West Don Lands Block 13

Schematic Design
June 26, 2024

Review Stage: Schematic Design

WATERFRONT TORONTO DRP #2

Shape of NE Tower Adjusted

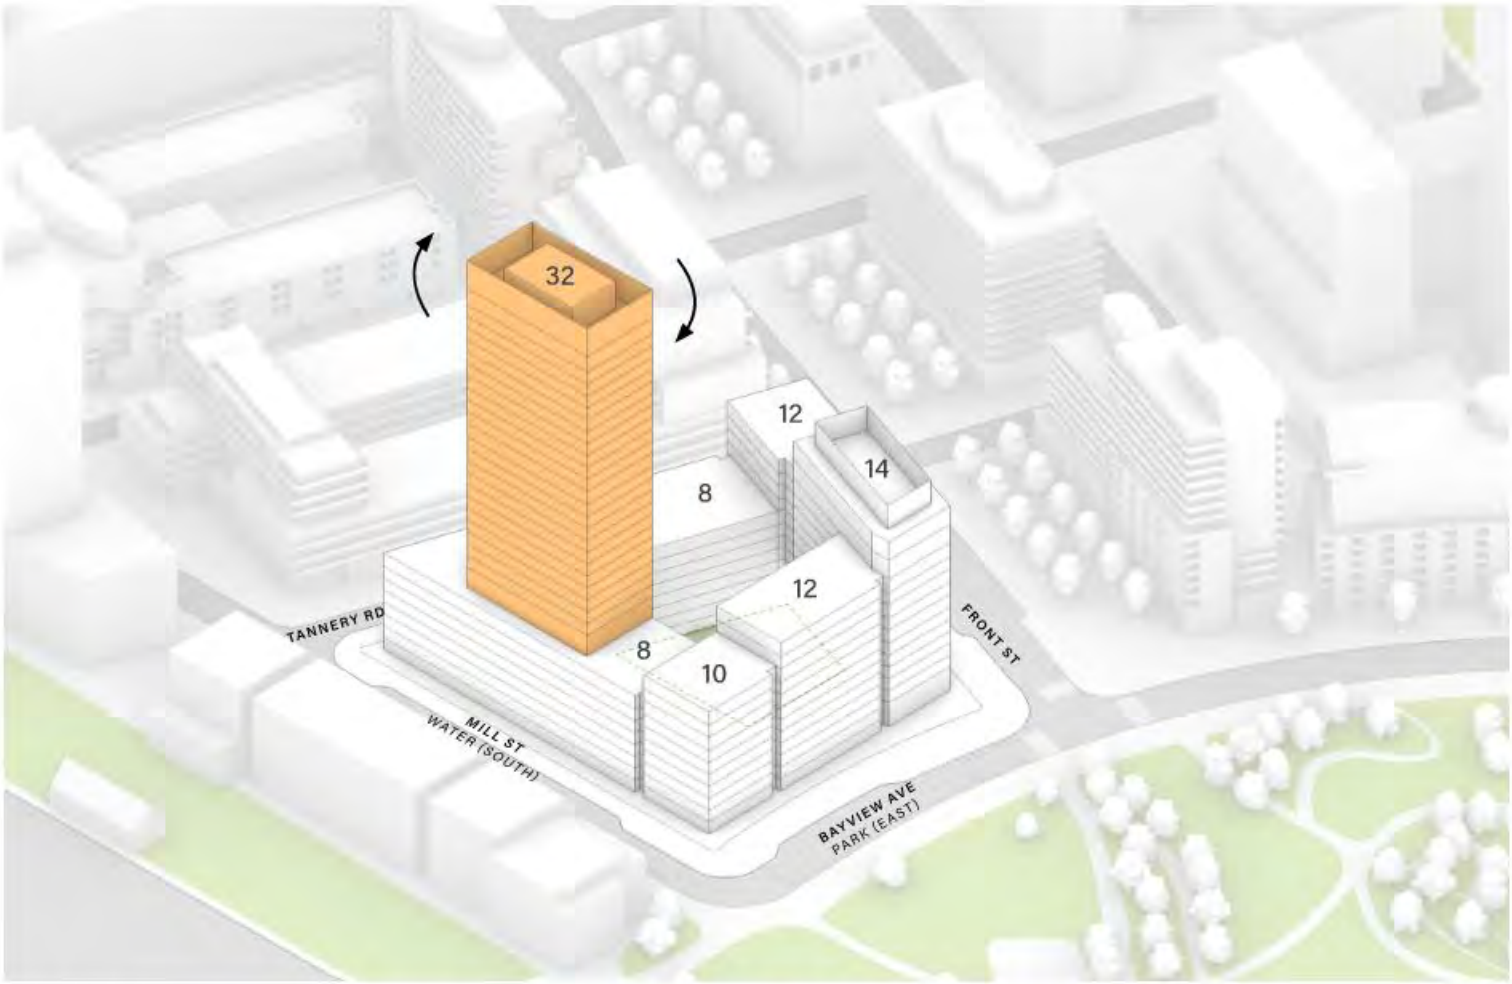
1. Tighten or eliminate the radius at the NE corner
2. The SW tower should be relocated along Mill Street
3. Symmetry between Block 13 and Block 4 is essential to respect the Block Plan
4. The height of the NE Tower should be 16 storeys to match Block 4
5. The podium on Front and Bayview should be 12 storeys to match Block 4
6. The podium on Tannery and Mill should be 5 storeys to relate to Block 12 and allow more sunlight into the courtyard
7. The design should continue the arc established by Block 4 along Bayview
8. The podium on Front and Bayview should be broken up to reduce the scale in reference to Block 4
9. The tower height remains a concern for shadows on the park
10. The SW tower floor plate should be reviewed to mitigate the size of the tower
11. The SW tower should be setback from Tannery Road
12. Maintain a minimum of 18m separation between the SW tower and podium

- Radius at NE corner has been eliminated
